**ADDENDUM NO. 2**

**ALTERATIONS & ADDITIONS TO:  
POLICE ANNEX TRAINING CENTER  
MARKET COMMON**

Myrtle Beach, South Carolina  
December 12, 2019

**FIRING RANGE LAYOUT BASE BID**

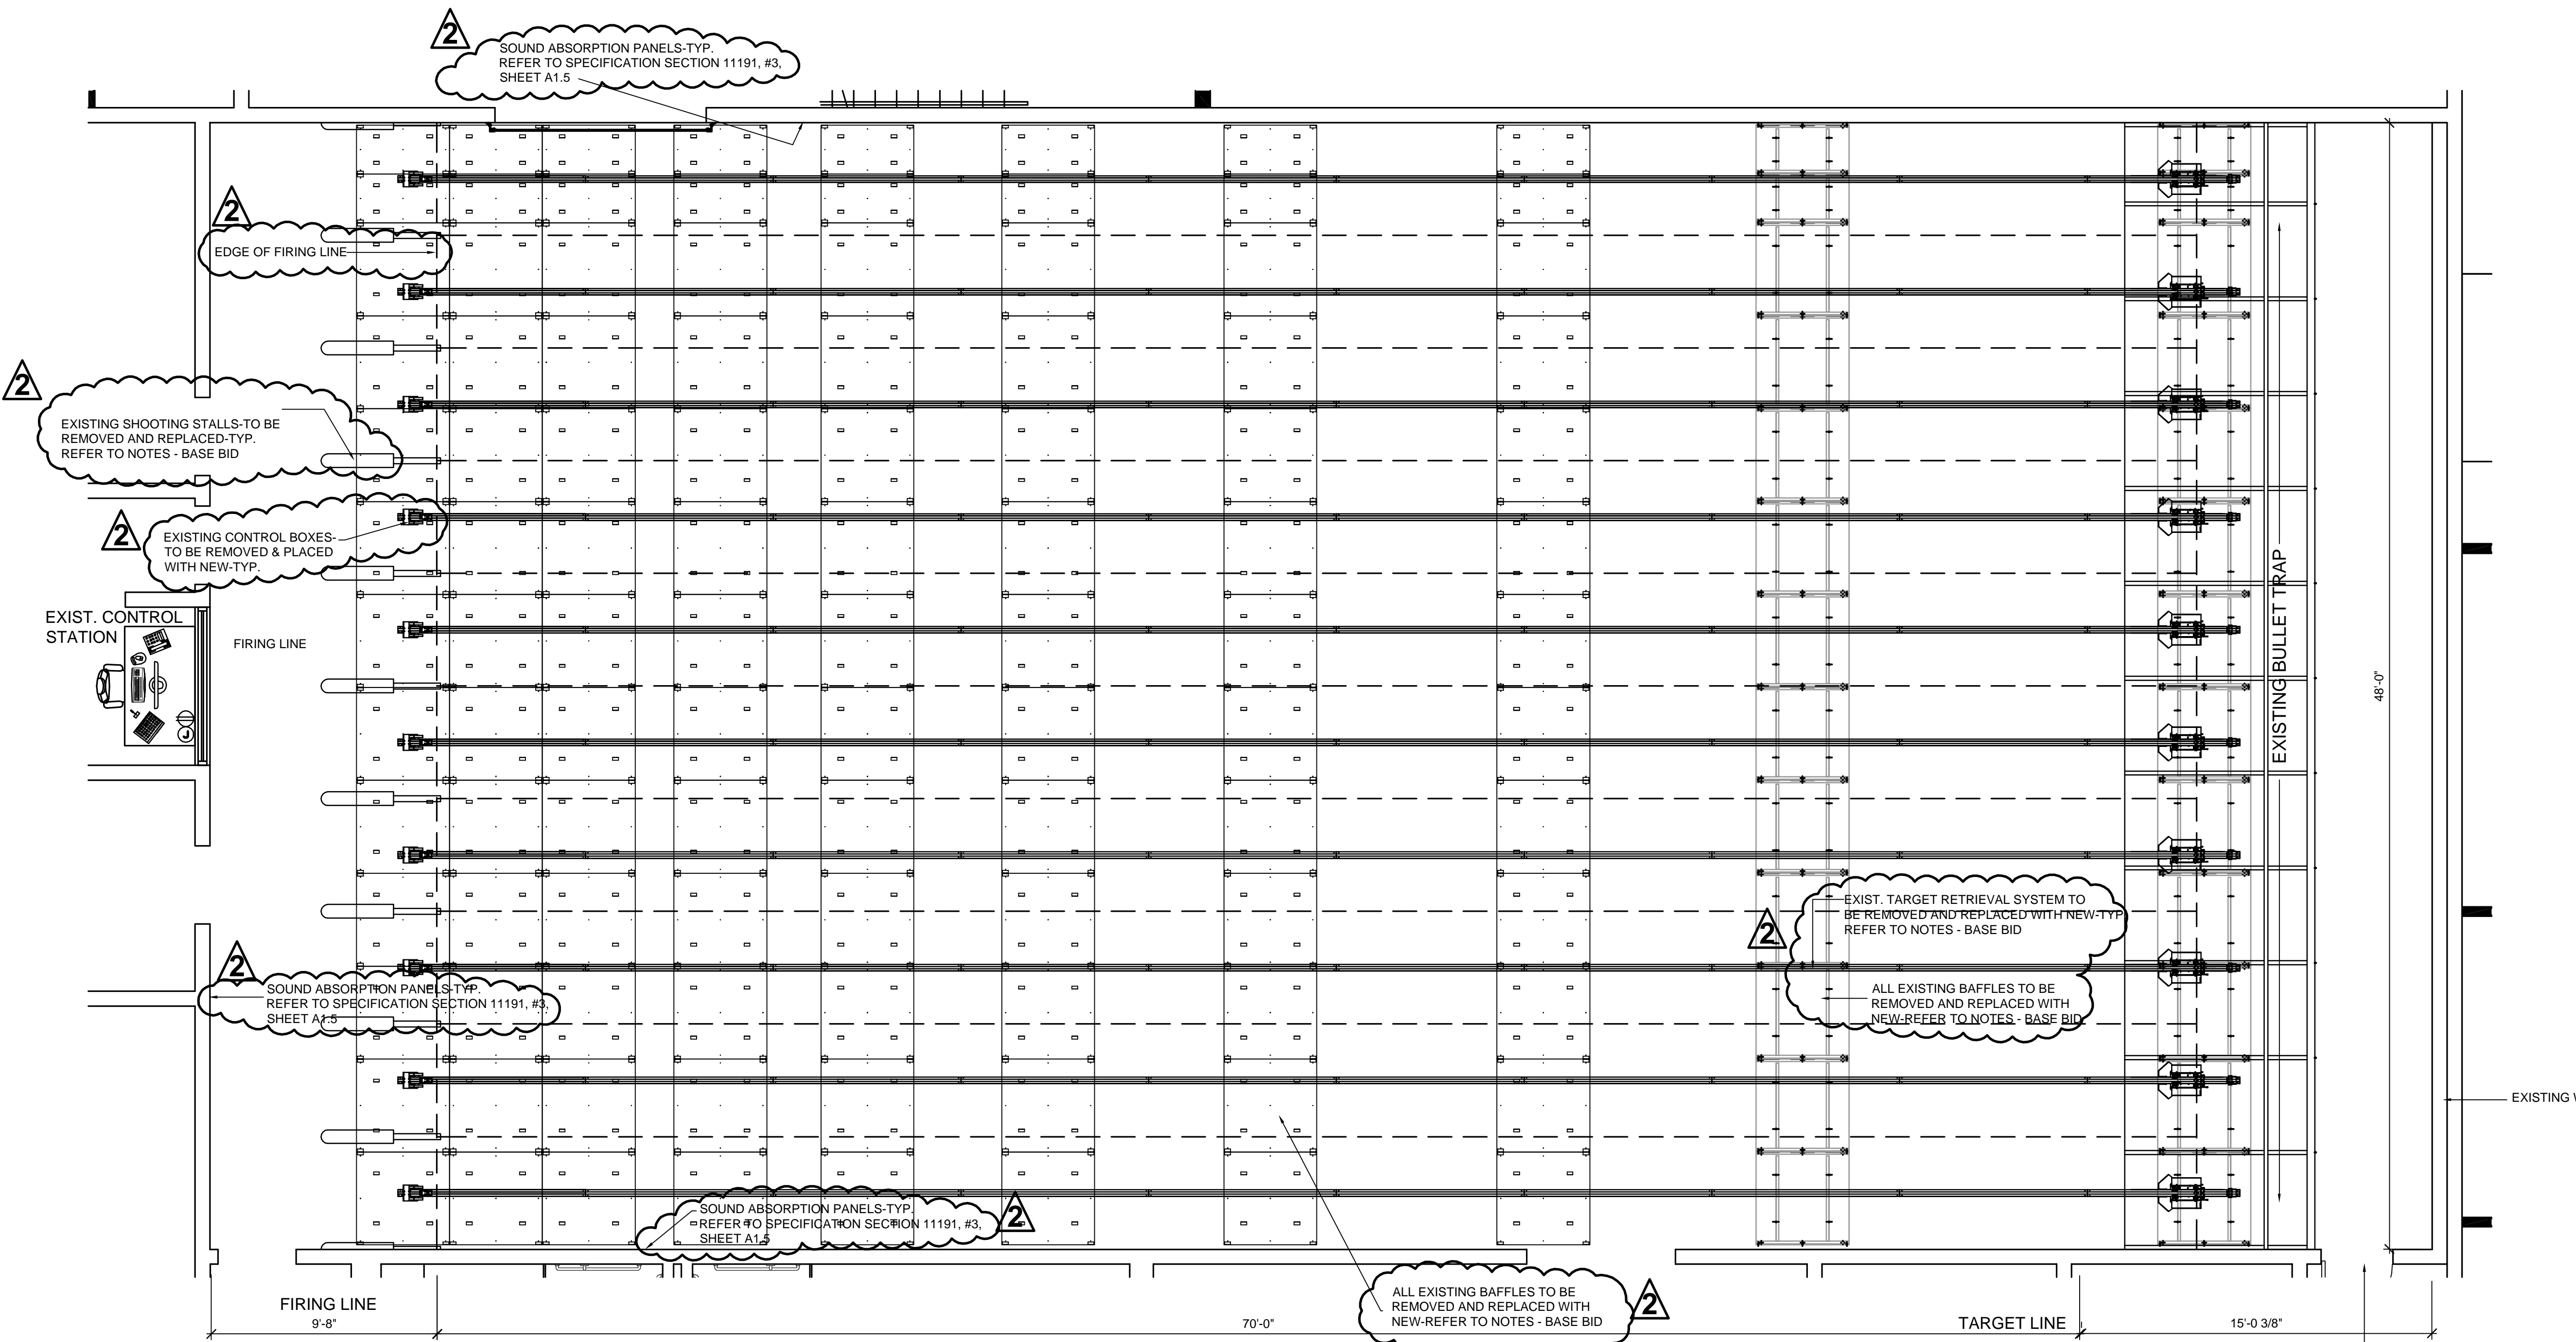
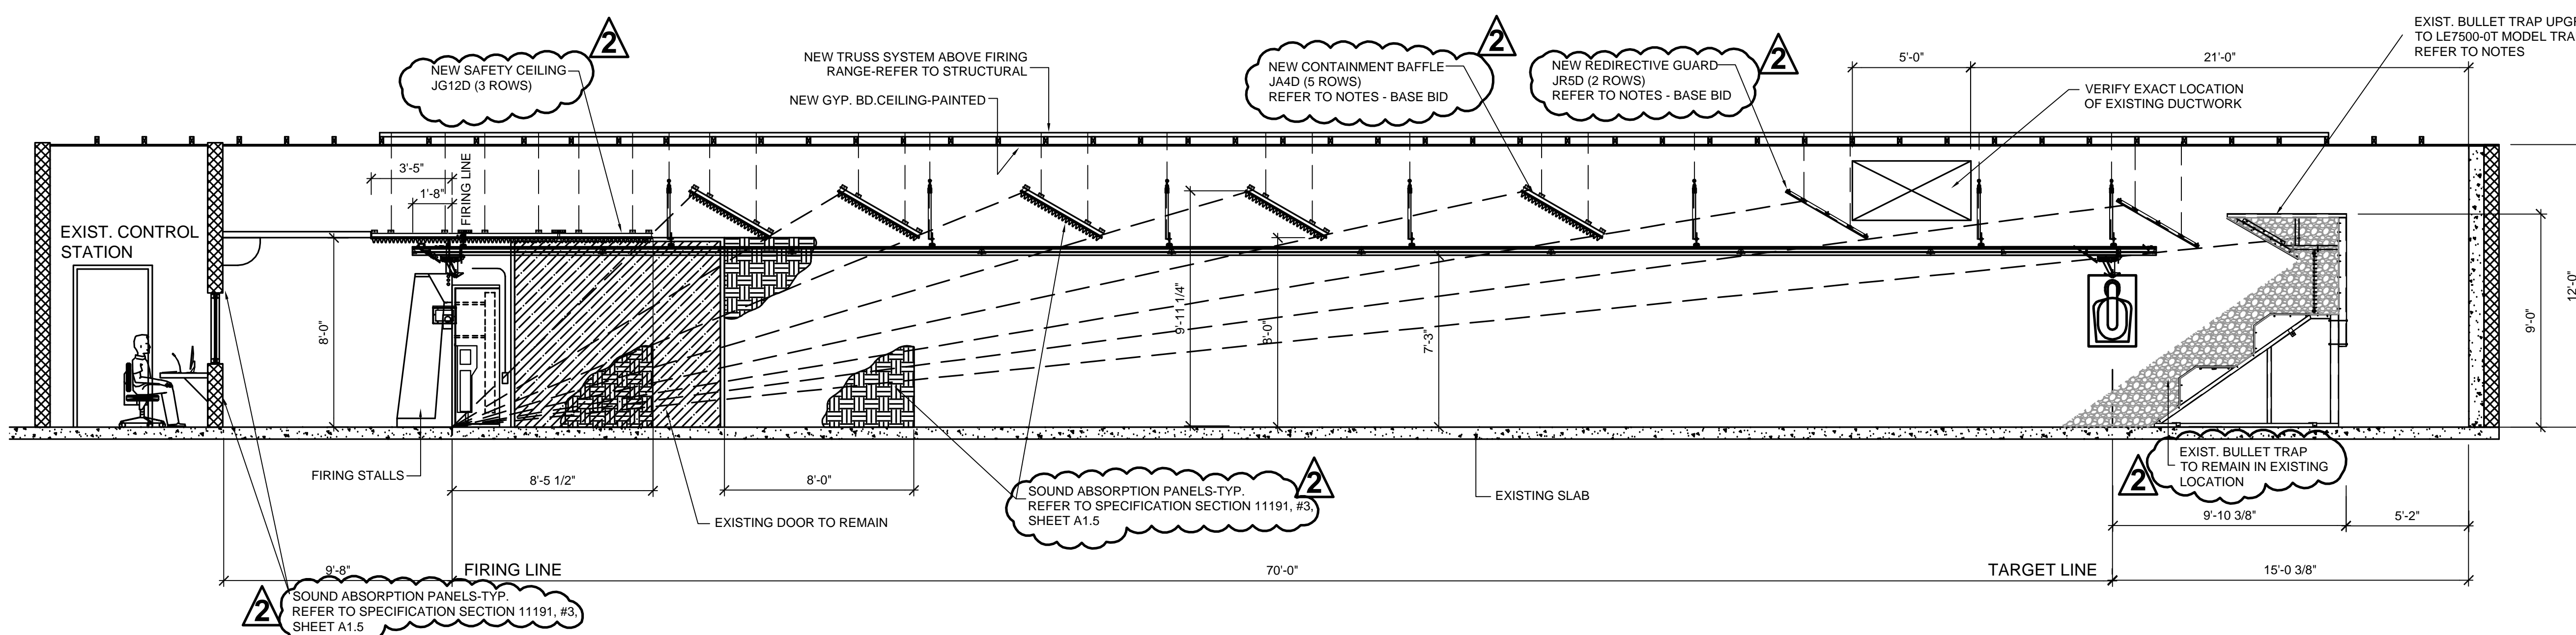
"A1.4 – FIRING RANGE LAYOUT ALTERNATE #2  
A1.5 – FIRING RANGE SPECIFICATIONS"
2. SHEET A1.3 – FIRING RANGE LAYOUT – BASE BID
  - A. Contractor's attention is directed to SHEET A1.3 – FIRING RANGE LAYOUT – BASE BID. Contractor is advised to omit this sheet in its entirety and replace with SHEET A1.3 – FIRING RANGE LAYOUT – BASE BID (attached herewith) consisting of 1 page dated 12/12/19 for revisions.

**1 FIRING RANGE LAYOUT - ALTERNATE #2**  
**A1.4** SCALE: 1/4"=1'-0"

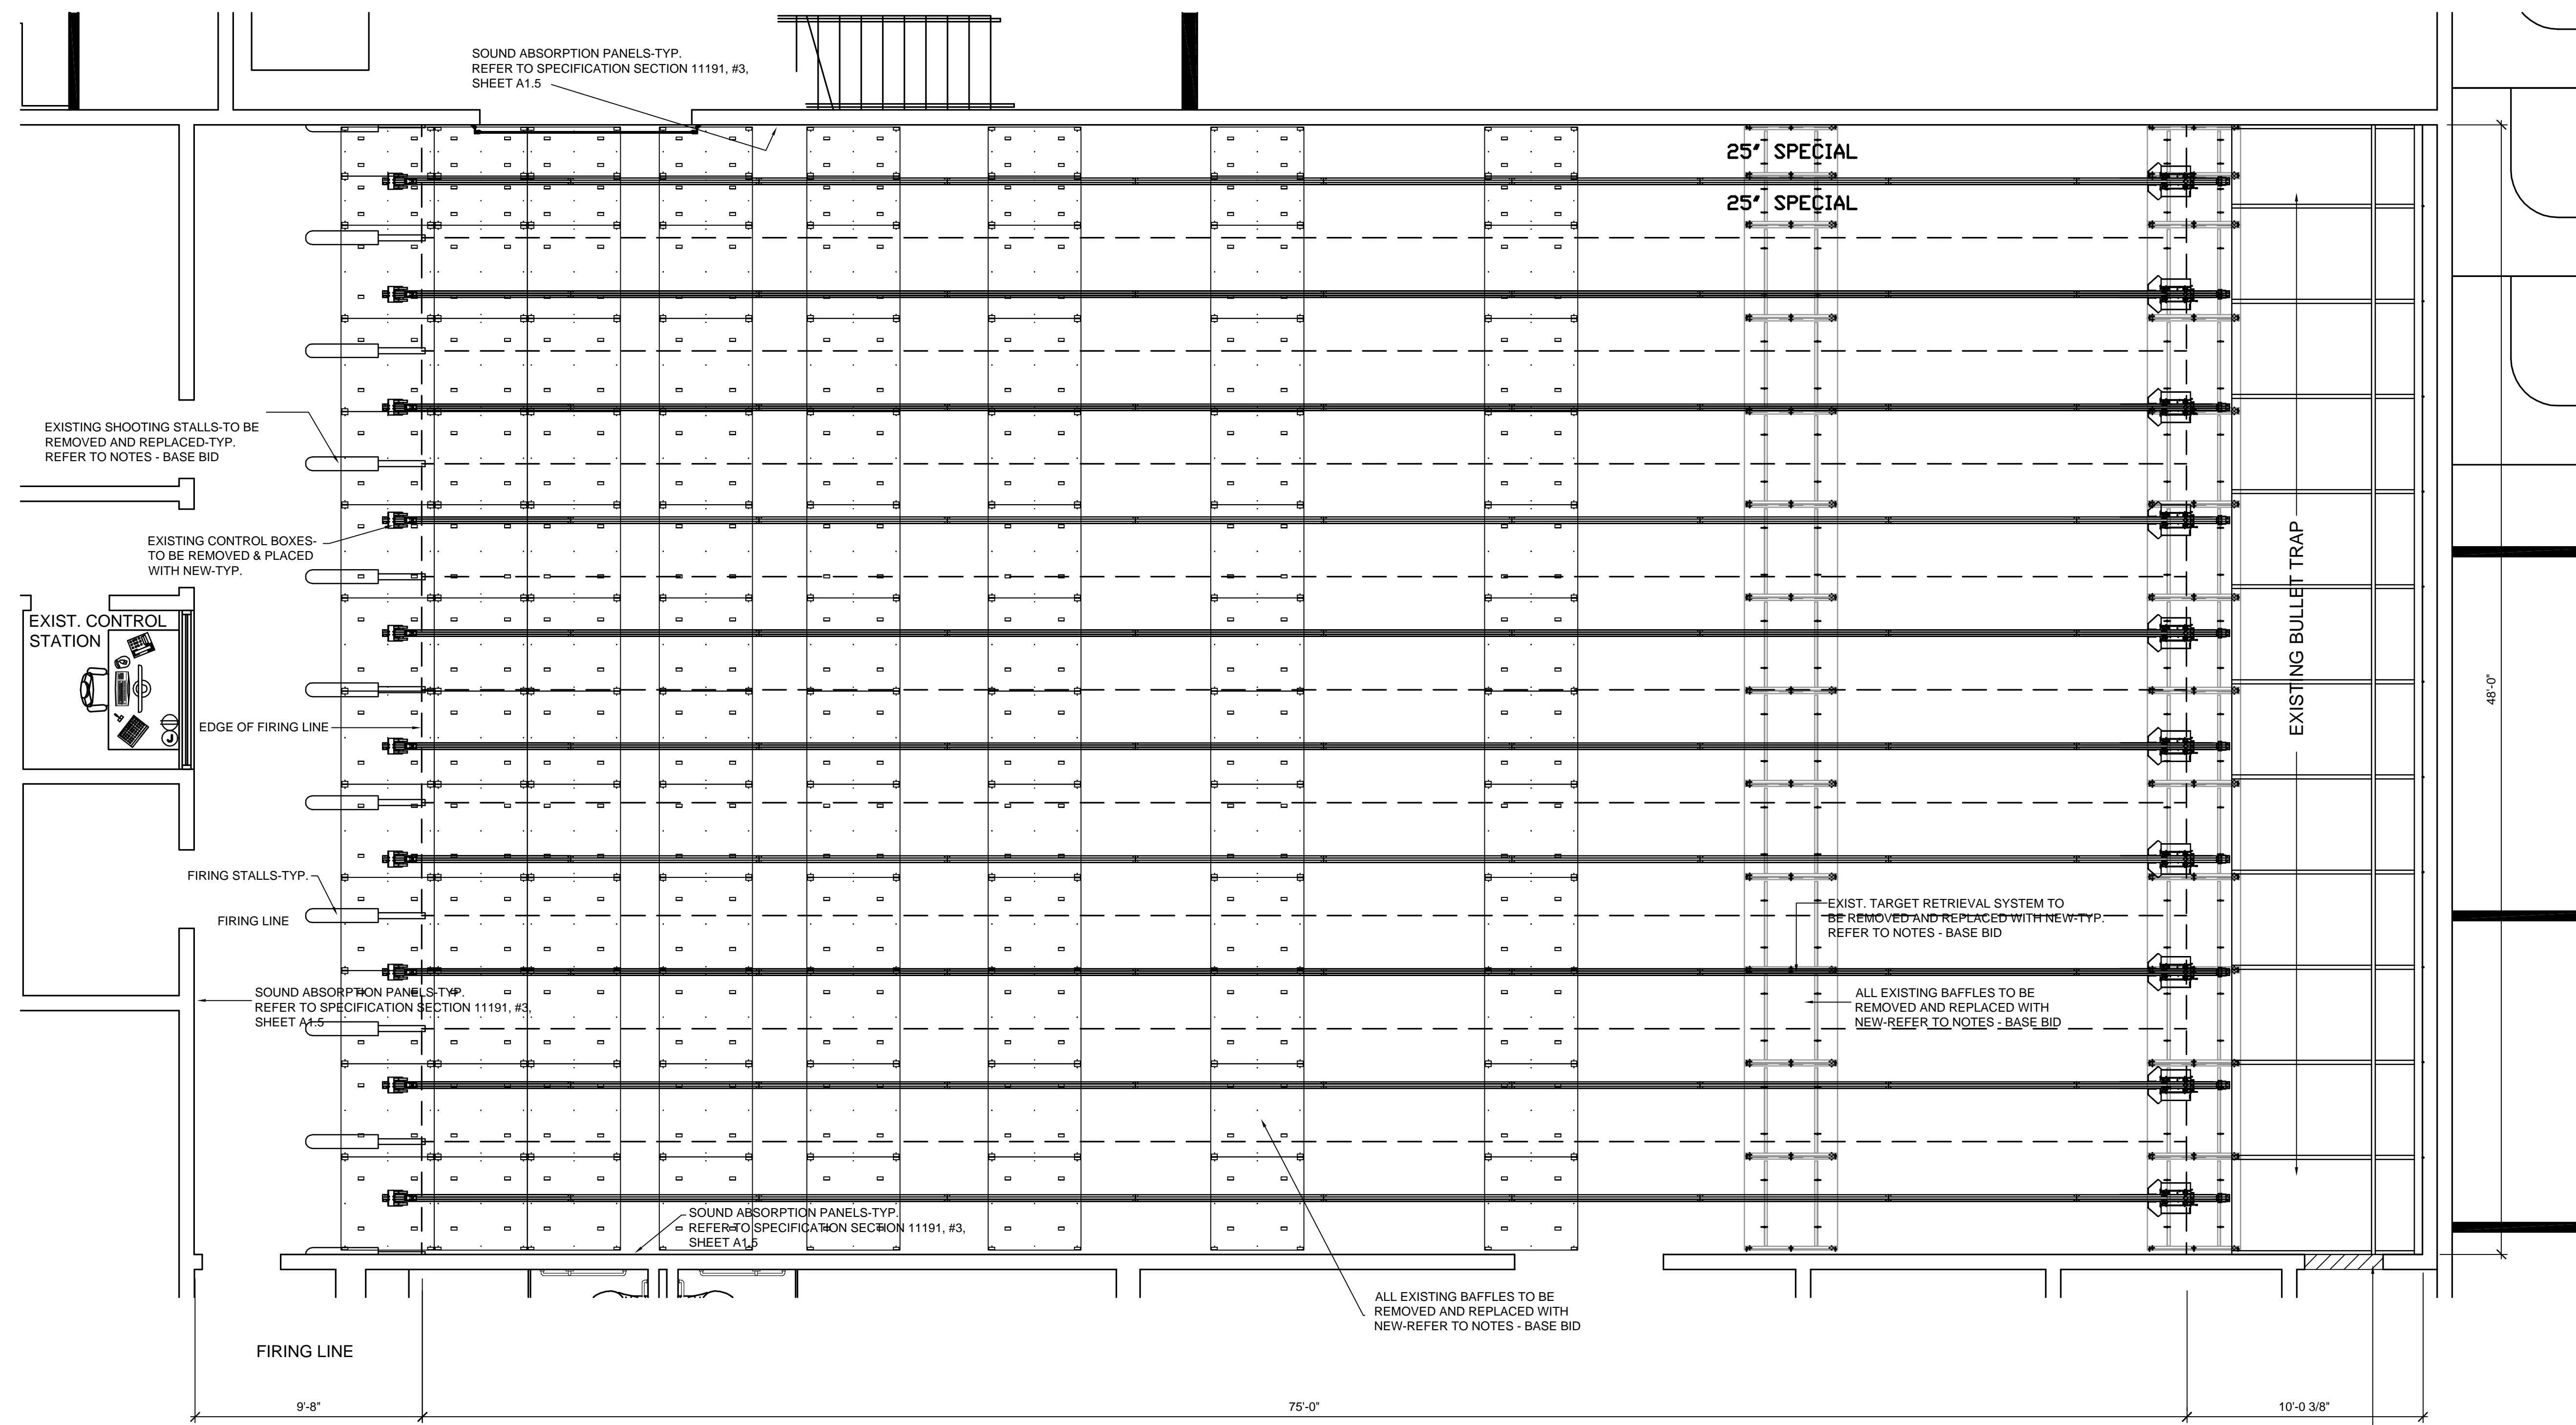
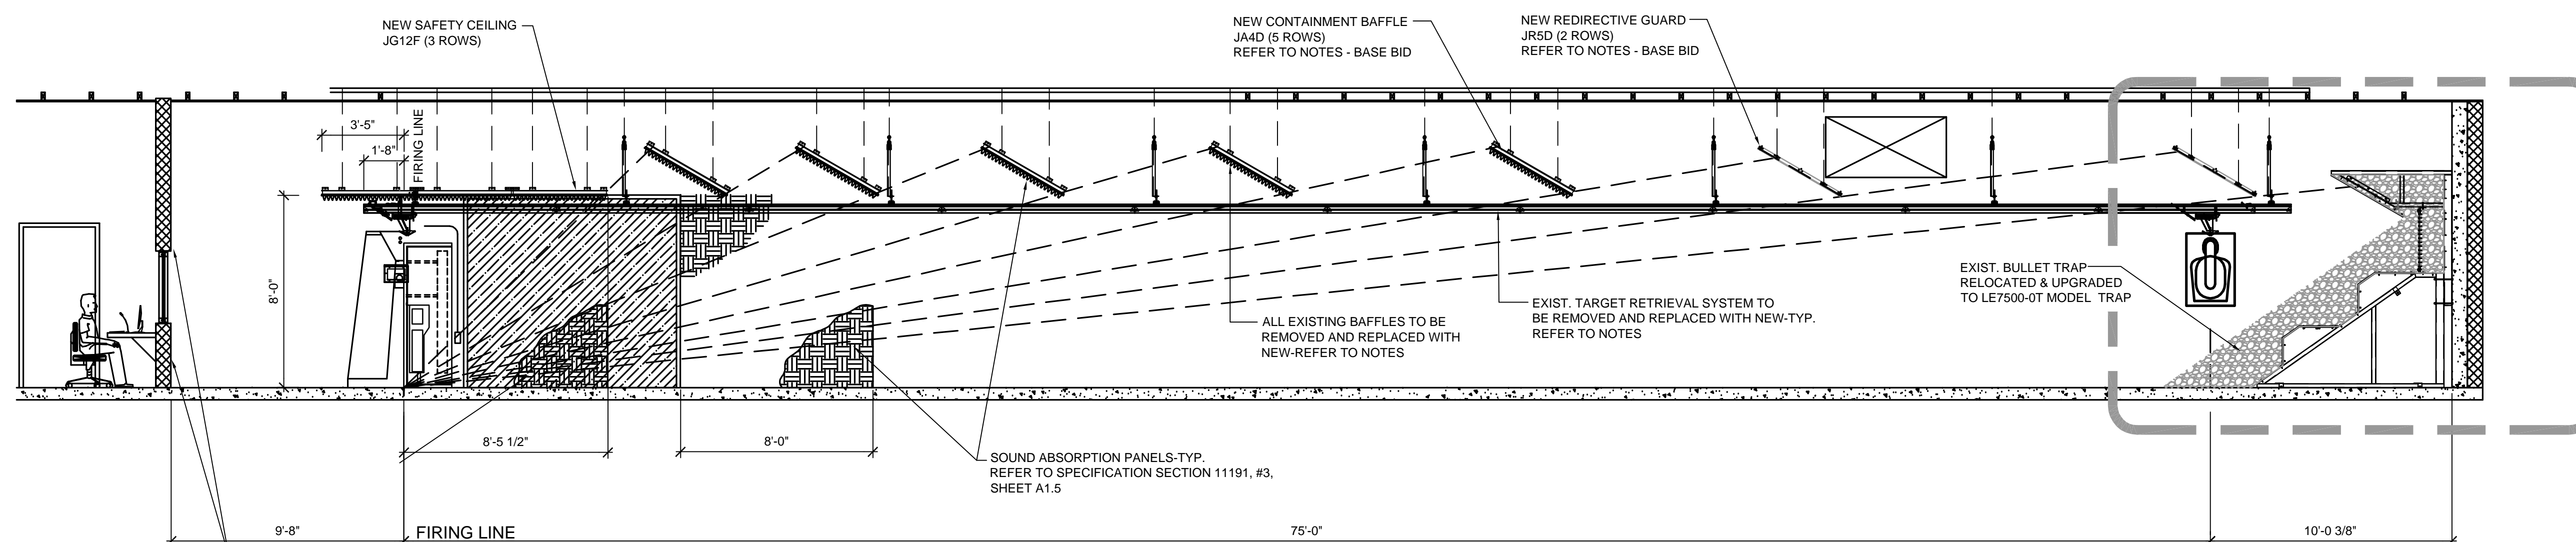
3. SHEET A1.4 – FIRING RANGE LAYOUT ALTERNATE #2
  - A. Contractor's attention is directed to SHEET A1.4 – FIRING RANGE LAYOUT ALTERNATE #2. Contractor is advised to insert SHEET A1.4 – FIRING RANGE LAYOUT ALTERNATE #2 (attached herewith) consisting of 1 page dated 12/09/19 as a new sheet.

ALTERNATE #2:  
 EXISTING DOOR & FRAME TO BE REMOVED. FILL-IN OPENING TO MATCH EXISTING MATERIALS AND FINISHES.

- RE-LOCATE EXISTING BULLET TRAP AND UPGRADE TO MEGGITT MODEL LE7500-OT (BASIS OF DESIGN)
- GENERAL CONTRACTOR SHALL REMOVE STEP BED PLATE DESIGN
- RELOCATE THE BOX TUBE FRAME TO THE BACK WALL REINSTALL FRAME ASSEMBLY.
- INSTALL THE UPPER RE-DIRECTED GUARD.
- REINSTALL STEP BED PLATES
- PAINT RED GRANTEX DEPTH SAFETY LINE ON SIDE WALLS AN FRONT EDGE.
- REFILL GRANTEX WITH THE EXISTING GRANTEX GRANULATED MATERIAL.

**1** **EXIST. DARKROOM SINK TO REMAIN FUNCTIONAL - ADD #2**  
**B2** SCALE: NTS

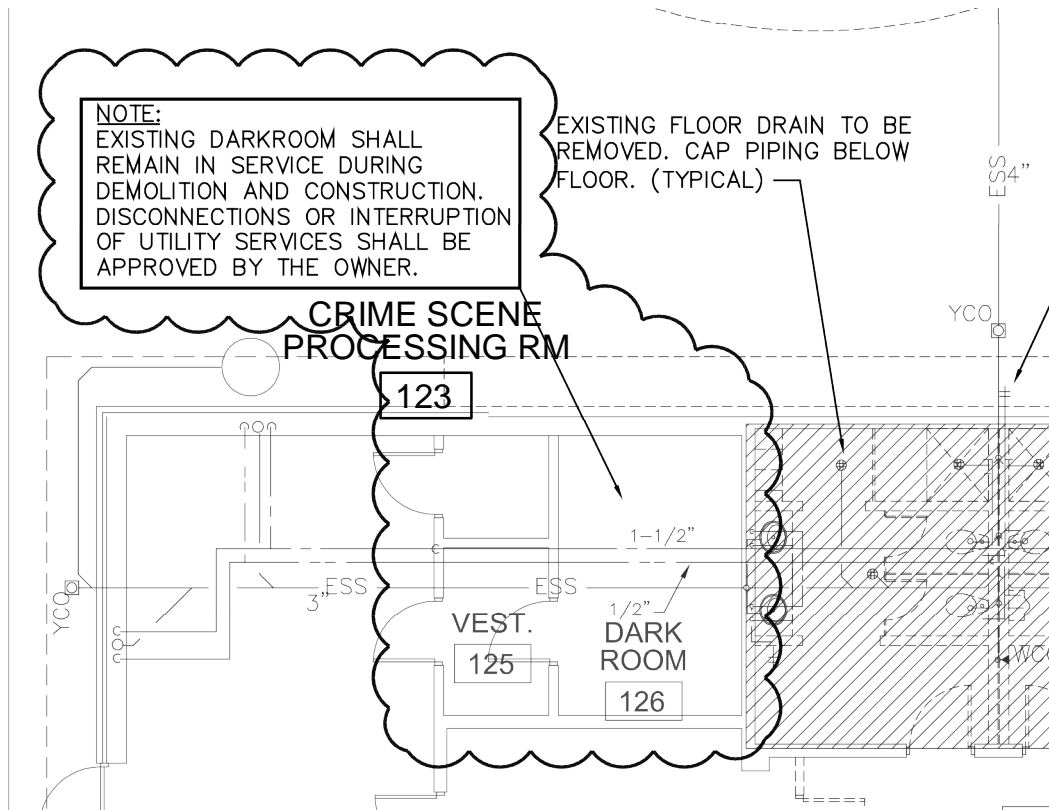
5. SHEET DP1.1 – PLUMBING DEMOLITION PLAN
  - A. Contractor's attention is directed to Bulletin Drawing B2 (attached herewith) consisting of 1 page dated 12/09/19 for revisions to Dark Room space 126.
